UTS Site Building 13-15
Master Plan -
Ultimo Precinct, Haymarket
Stage A - Public Domain

Access Review
Concept Design - Final

29 July 2021

MGAC Markup
050721_Draft

DRAWING NUMBER
AR-B10 00-00

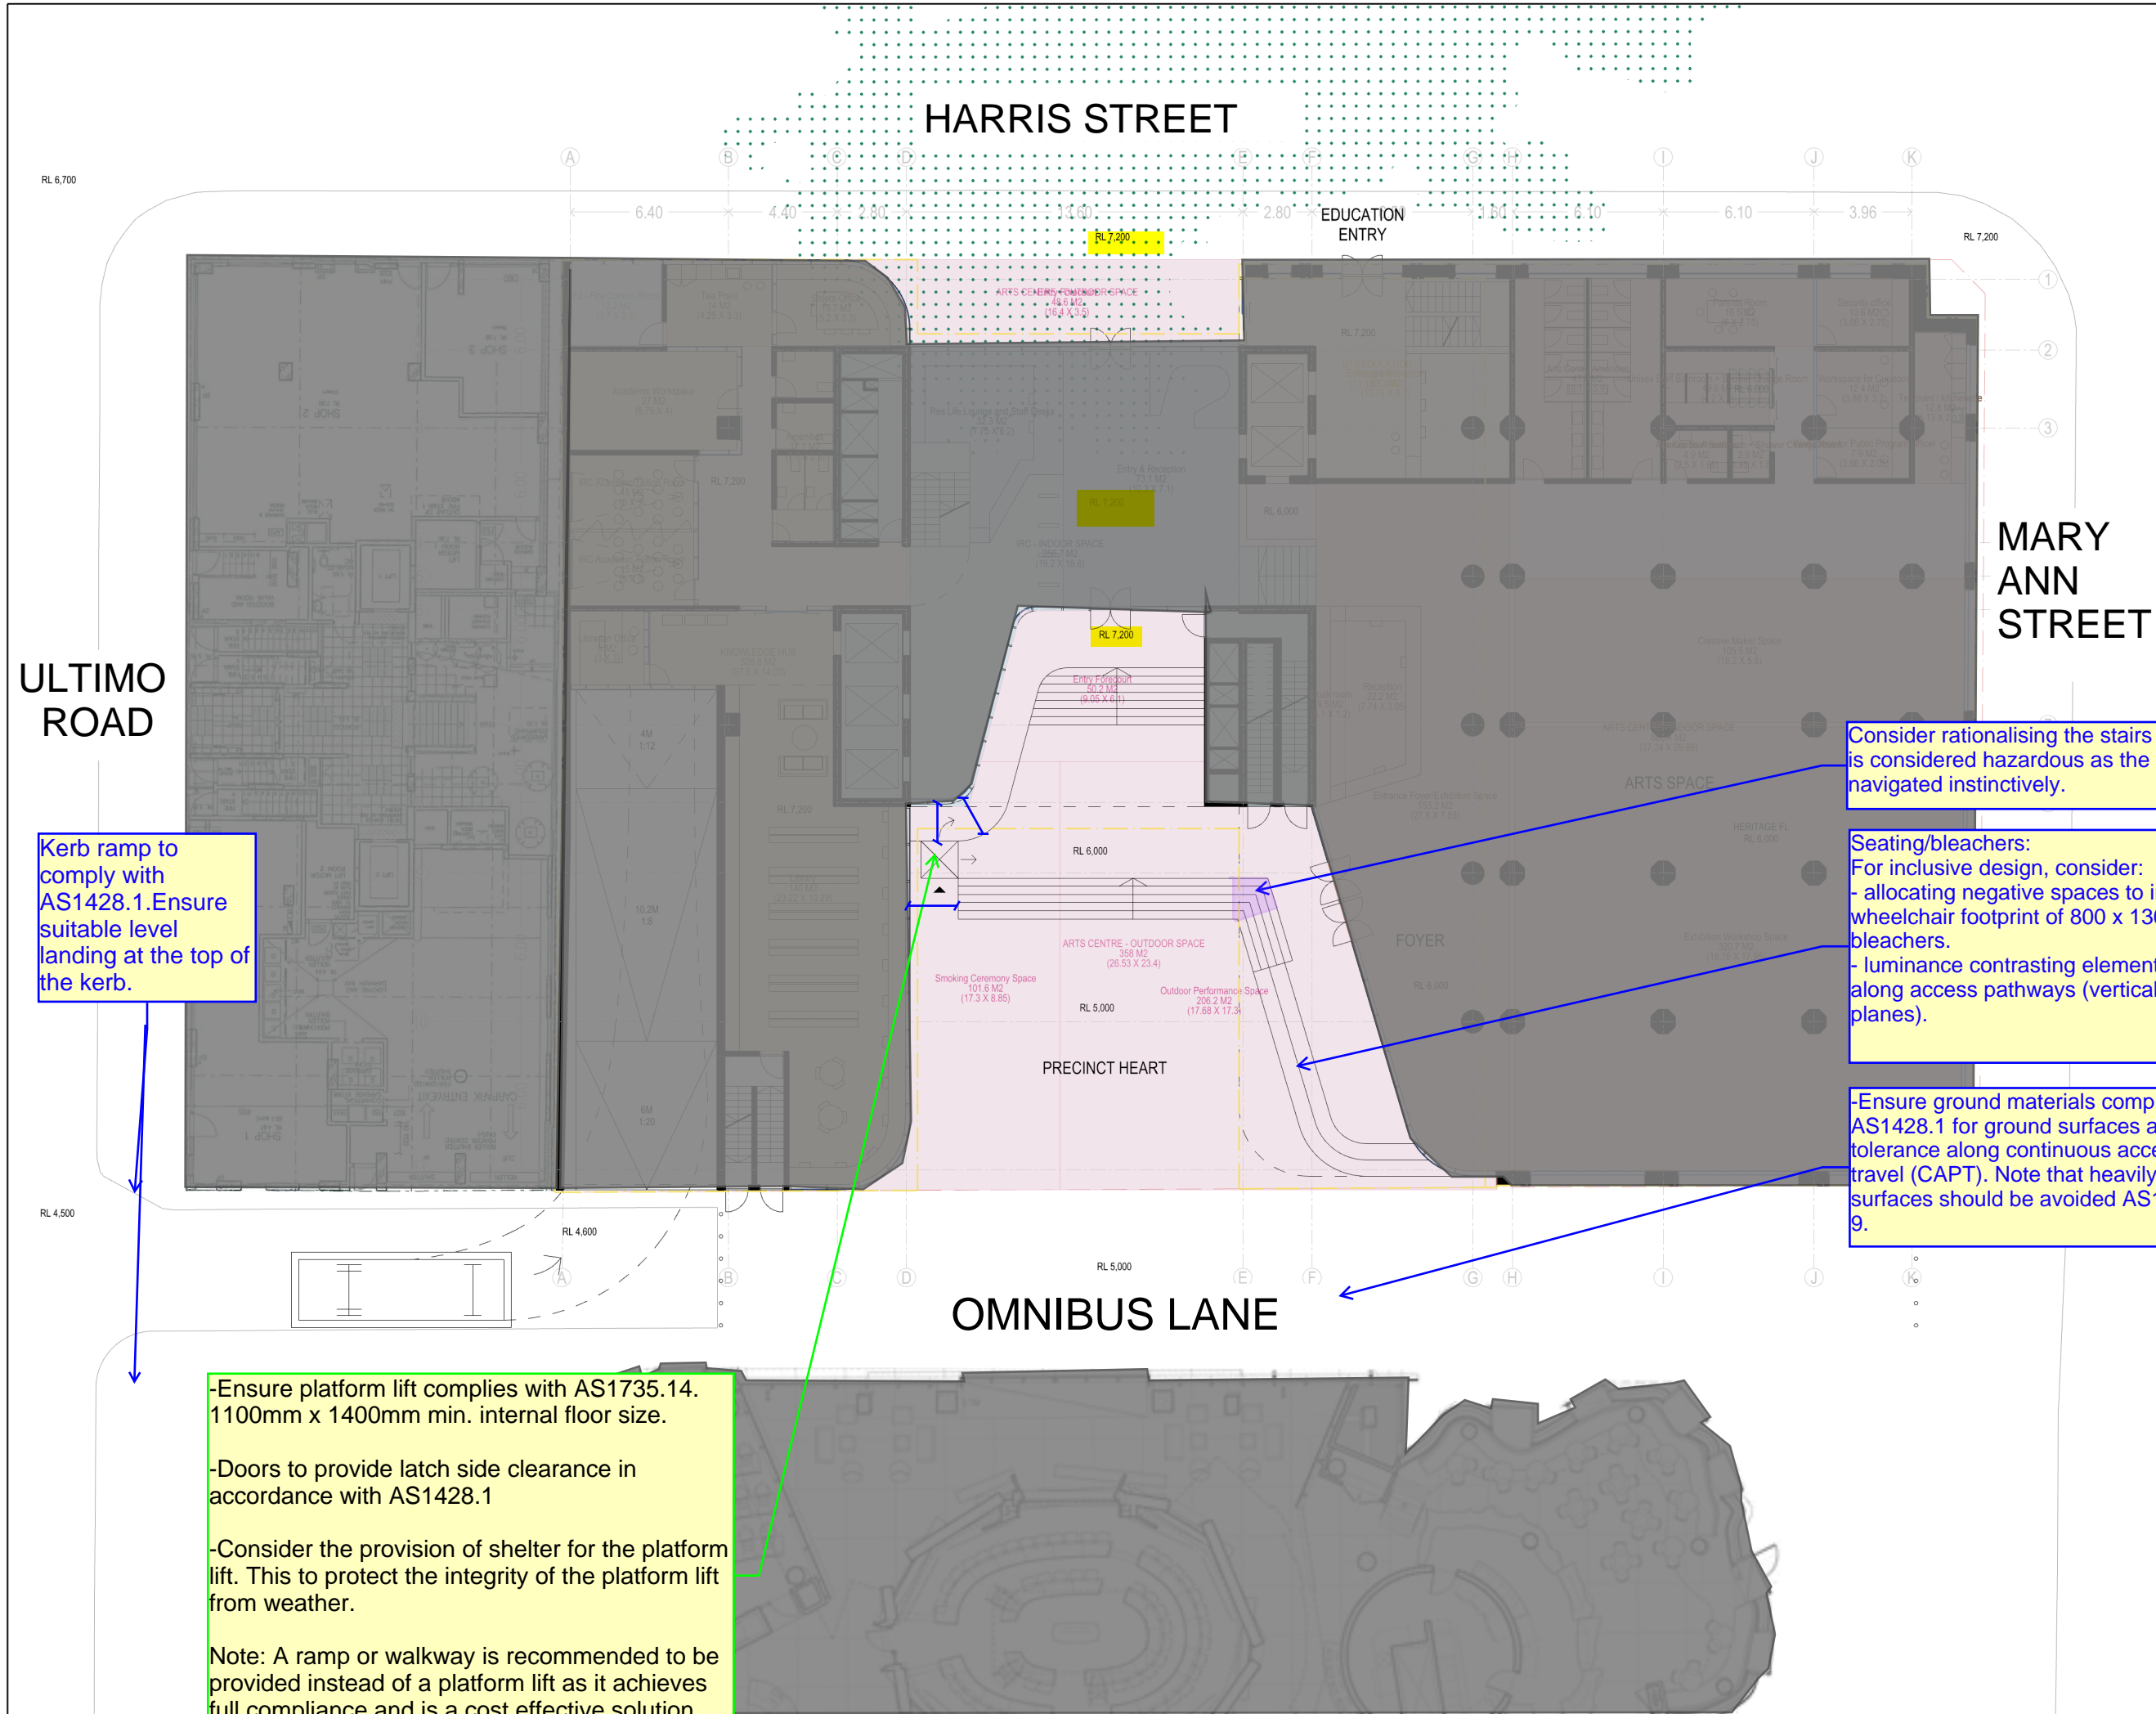
Consider rationalising the stairs as this corner is considered hazardous as the stair cannot be navigated instinctively.

Seating/bleachers:
For inclusive design, consider:
- allocating negative spaces to include a wheelchair footprint of 800 x 1300mm to bleachers.
- luminance contrasting elements to obstacles along access pathways (vertical and horizontal planes).

-Ensure ground materials comply with AS1428.1 for ground surfaces and vertical tolerance along continuous accessible path of travel (CAPT). Note that heavily textured surfaces should be avoided AS1428.2 Clause 9.

-Ensure platform lift complies with AS1735.14. 1100mm x 1400mm min. internal floor size.

-Doors to provide latch side clearance in accordance with AS1428.1

-Consider the provision of shelter for the platform lift. This to protect the integrity of the platform lift from weather.

Note: A ramp or walkway is recommended to be provided instead of a platform lift as it achieves full compliance and is a cost effective solution with low maintenance.
